Evaluator: CLP/EFA/BL

Date: 06/28/2019

UC Santa Cruz Building Seismic Ratings
Crown Library Study Building

CAAN #7162

Interior Transverse (E-W) Building Structural Section 8/S6 (Looking North Showing Overhangs, Vertical Offsets, and Cross-Grain Bending at Connections to Foundation Walls)

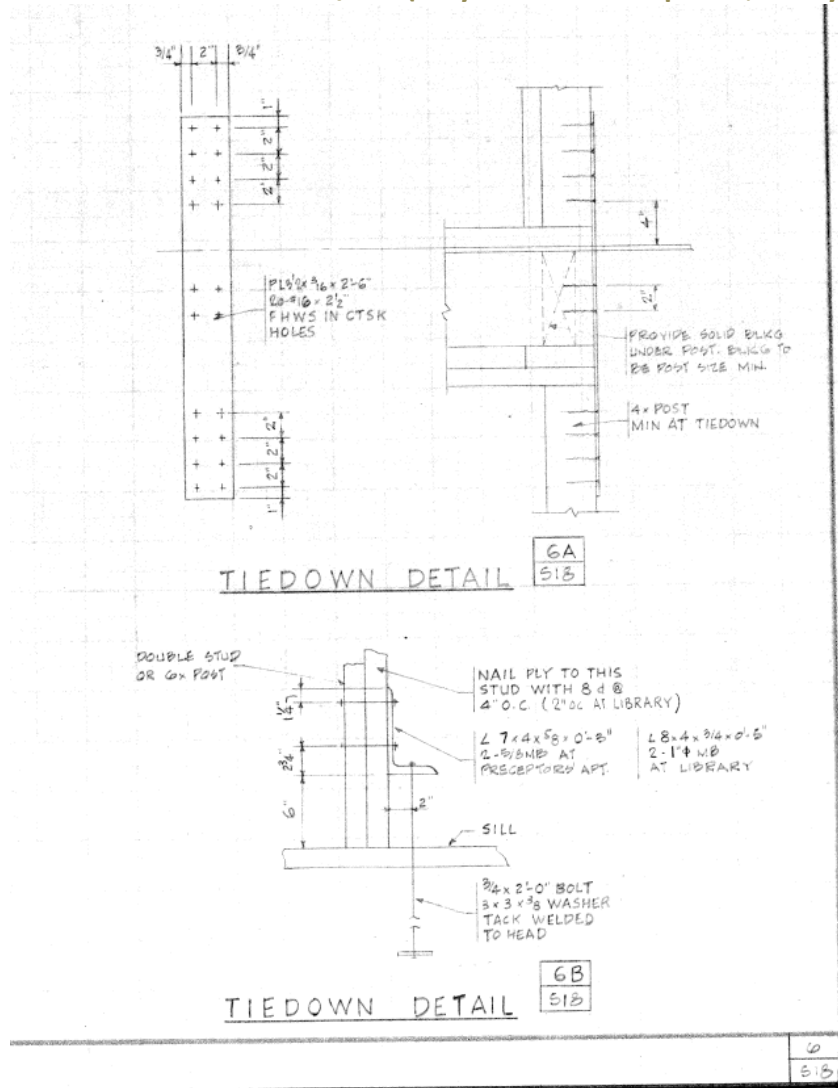
- The building has apparent geometric vertical discontinuities in both directions and lacks a clear load path for loads from the extended floor and patio areas at the third floor to the walls below. Some floors and walls are wider at the third floor than at the second floor and lack straps and hold downs to transfer forces and resist overturning. Only one location indicated a tiedown detail at the lower floor.
- Cross-grain bending is present in wood ledgers where the floor or stair framing connects to the concrete stem walls and where the bridge is anchored to the stair towers.
- Potential for pounding between the bridge structure and the stair towers in between floor or stair landing levels may result in damage to the exit stairs.

Framing Notes Call for 3/8" Sheathing at all Perimeter Walls

include hold downs and straps between floors at vertical discontinuities. A clear load path should be provided for projecting areas at the third floor at the perimeter. We assign the building to Priority Category B, as the retrofit of the building should be done when there are any plans for modifying or change of occupancy. Falling hazards reduction, such as the tile roofs adjacent to exits or footpaths, should be given a higher priority.

"Tiedown Detail" 6A&6B/S18 (only used at a few places, not typical at all wall ends)

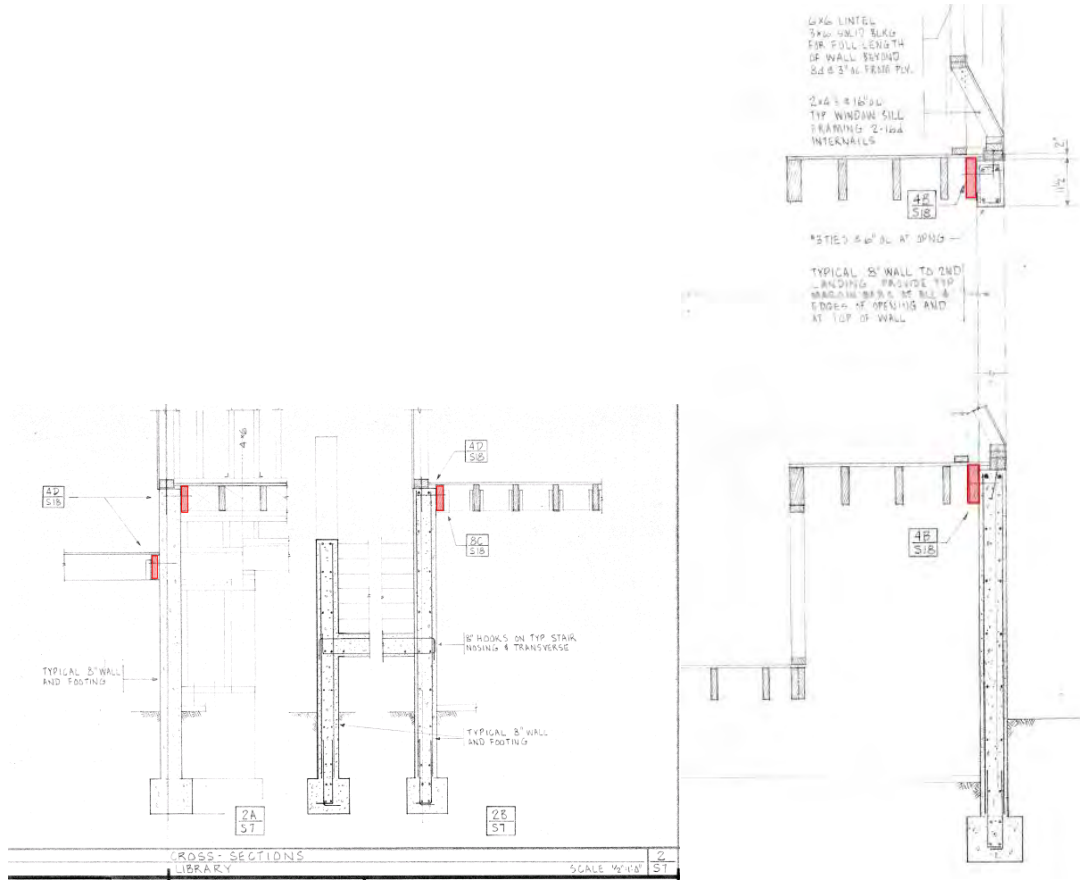
<p>Comments: Appears all walls single sided 3/8 ply; maximum shear stress at 2nd floor is 597plf in the longitudinal (N-S) direction and 582 pf in the transverse (E-W) direction.</p>	Structural panel sheathing	1,000 lb/ft	Diagonal sheathing	700 lb/ft	Straight sheathing	100 lb/ft	All other conditions	100 lb/ft
Structural panel sheathing	1,000 lb/ft											
Diagonal sheathing	700 lb/ft											
Straight sheathing	100 lb/ft											
All other conditions	100 lb/ft											
<input checked="" type="radio"/>	<input type="radio"/>	<input type="radio"/>	<input type="radio"/>	<p>STUCCO (EXTERIOR PLASTER) SHEAR WALLS: Multi-story buildings do not rely on exterior stucco walls as the primary seismic-force-resisting system. (Commentary: Sec. A.3.2.7.2. Tier 2: Sec. 5.5.3.6.1)</p> <p>Comments: Exterior walls are stucco over 3/8 plywood; not relying on stucco.</p>								
<input checked="" type="radio"/>	<input type="radio"/>	<input type="radio"/>	<input type="radio"/>	<p>GYPSUM WALLBOARD OR PLASTER SHEAR WALLS: Interior plaster or gypsum wallboard is not used for shear walls on buildings more than one story high with the exception of the uppermost level of a multi-story building. (Commentary: Sec. A.3.2.7.3. Tier 2: Sec. 5.5.3.6.1)</p> <p>Comments: Not relying on gypsum wallboard walls.</p>								
<input type="radio"/>	<input checked="" type="radio"/>	<input type="radio"/>	<input type="radio"/>	<p>NARROW WOOD SHEAR WALLS: Narrow wood shear walls with an aspect ratio greater than 2-to-1 are not used to resist seismic forces. (Commentary: Sec. A.3.2.7.4. Tier 2: Sec. 5.5.3.6.1)</p> <p>Comments: Includes many narrow piers beside windows with 3'6" or 5'7" that are less than 2-to-1..</p>								
<input type="radio"/>	<input checked="" type="radio"/>	<input type="radio"/>	<input type="radio"/>	<p>WALLS CONNECTED THROUGH FLOORS: Shear walls have an interconnection between stories to transfer overturning and shear forces through the floor. (Commentary: Sec. A.3.2.7.5. Tier 2: Sec. 5.5.3.6.2)</p> <p>Comments: Drawings show Simpson clips (A-1) and straps between floors and at base as "tiedown detail" but only find callout at one end of one stair well wall so not typical. .</p>

Cross-Grain Bending at Ledger Present in Typical Details 2/S7 and 8/S7

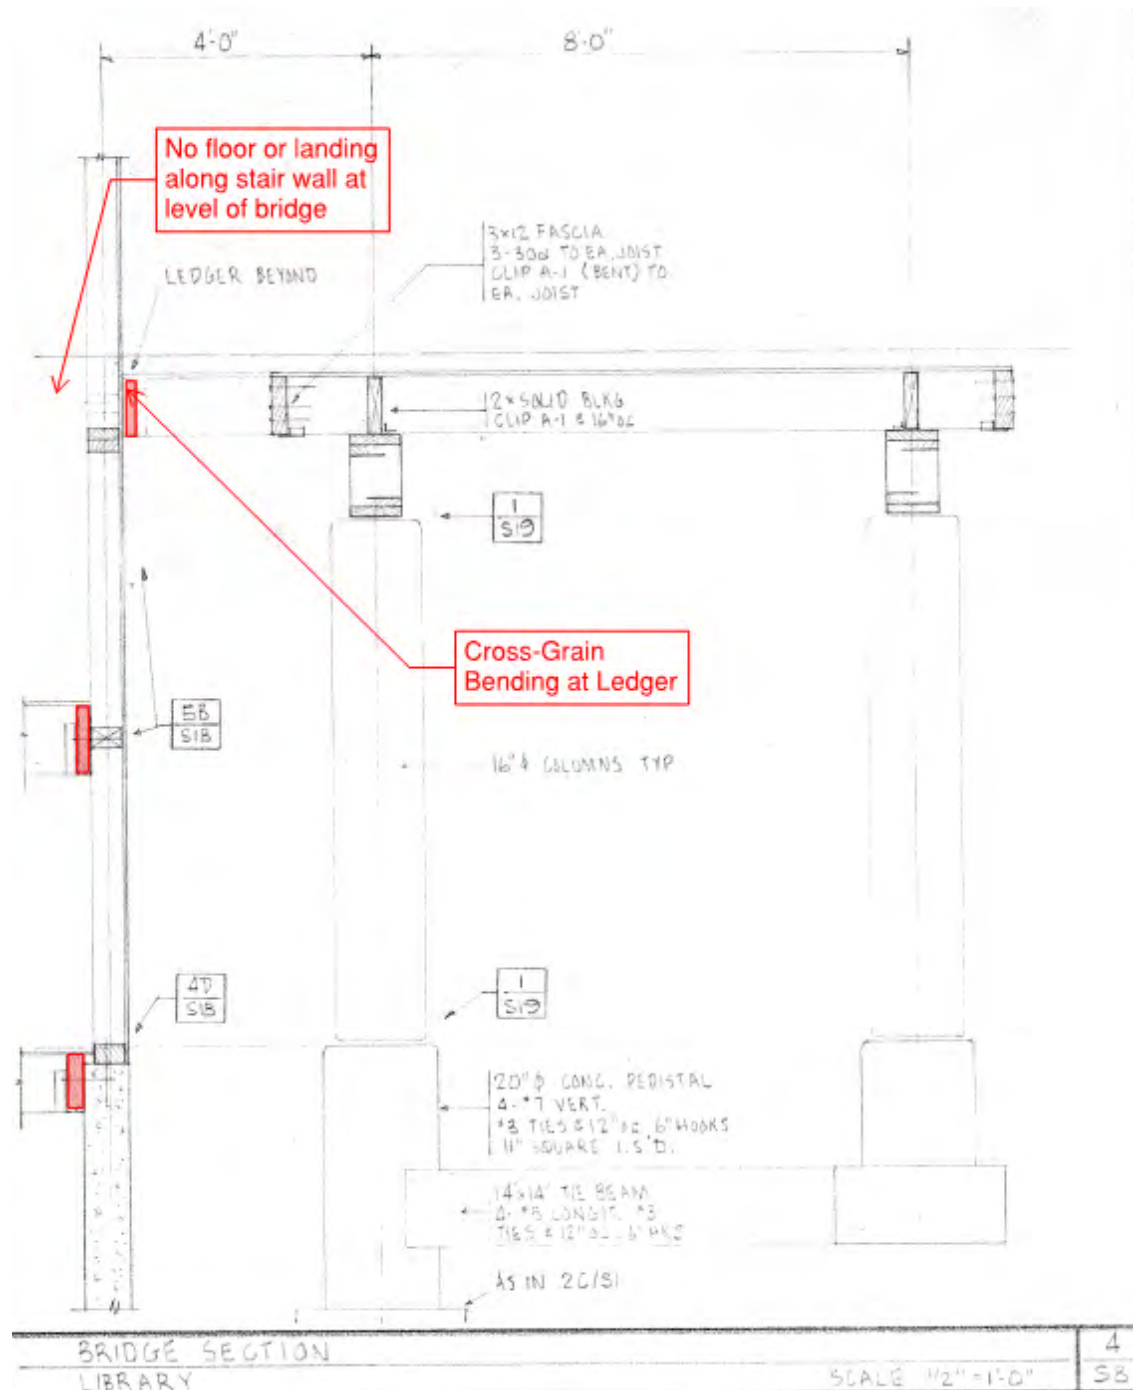
Structural system for lateral forces: Lateral forces are resisted by plywood shear walls in both the E-W and N-S directions. The building is nearly symmetric about a 45-degree axis and has roughly the same number of walls in each direction. The third floor is heavier than either the roof or second floor due to the large extended floor and patio areas that create vertical irregularities since the walls above do not align with walls below. The drawings state that all perimeter walls are to be sheathed with 3/8" plywood and in addition the cripple walls that align with perimeter walls above are also sheathed. The drawings include some Simpson hardware at the base of posts, some A1 clips for shear transfer, and some tiedowns that we could only locate at one end of each exterior stair wall. The load path from the extended floor and patio areas is unclear as there does not appear to be a mechanism to transfer loads delivered from these areas to the walls below. Details where the first floor or stair landings frame into the foundation walls include cross-grain bending in the ledger. The bridge structure relies on the Library for lateral support, but the connection details include ledgers with cross-grain bending.

Detail 4/S8 of Adjoining Bridge Structure Anchored to Library and Connecting to Classroom and Faculty Wing at Second Floor Level (No Floor Aligned with Bridge at this Section and Cross-Grain Bending at Connection Details)

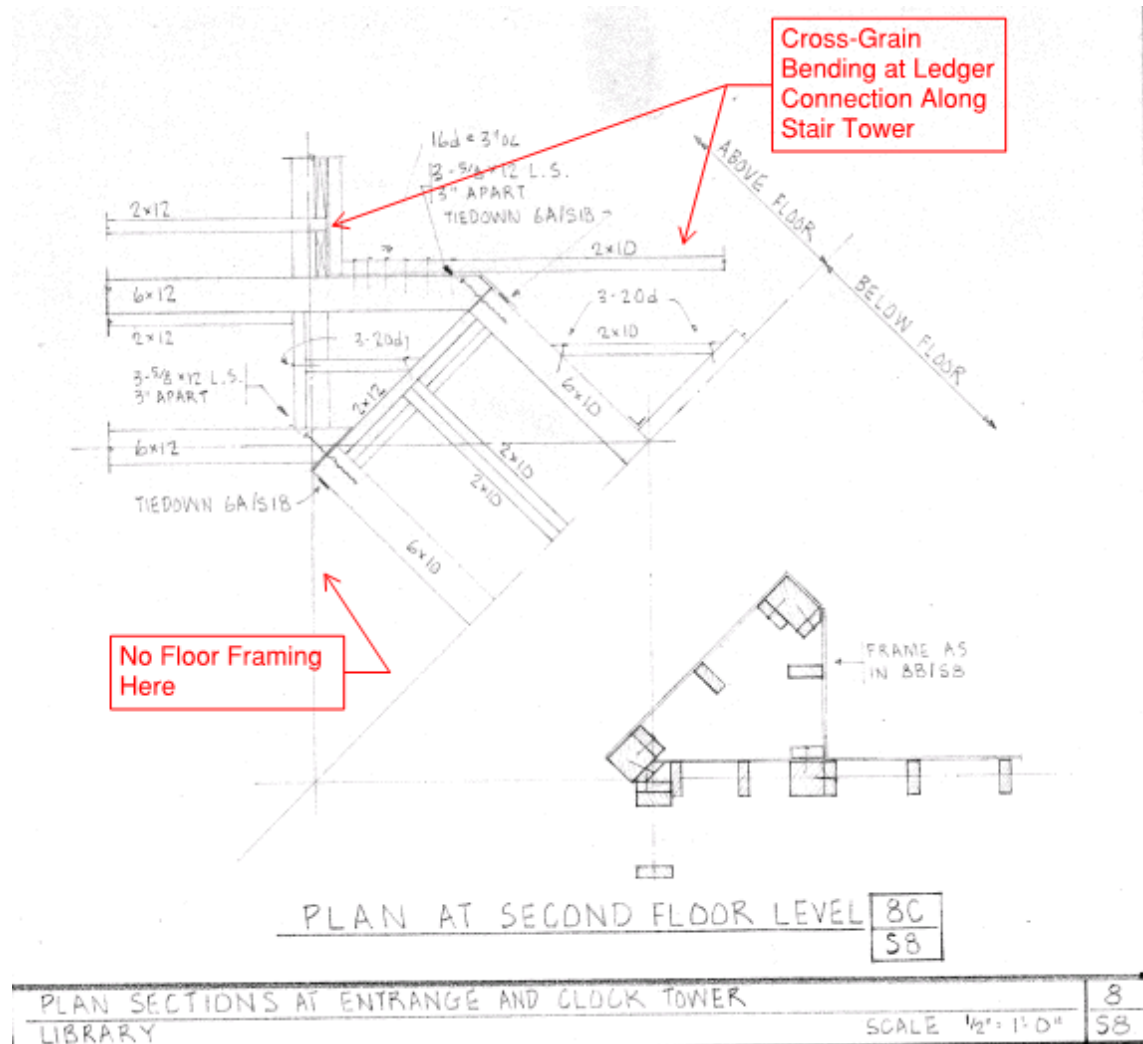
The Crown Library Study is linked to the Classroom Building and the Faculty Study Building by a one-story heavy timber pedestrian bridge at the second floor level. The bridge is anchored to the Library building along the face of the Clock Tower, the north wall of the east stair tower, and east wall of the north stair tower. Portions of the stair walls are vulnerable to pounding damage where the floors or landing do not align with the bridge deck. Connection details to the stair towers include a ledger connection with cross-grain bending.
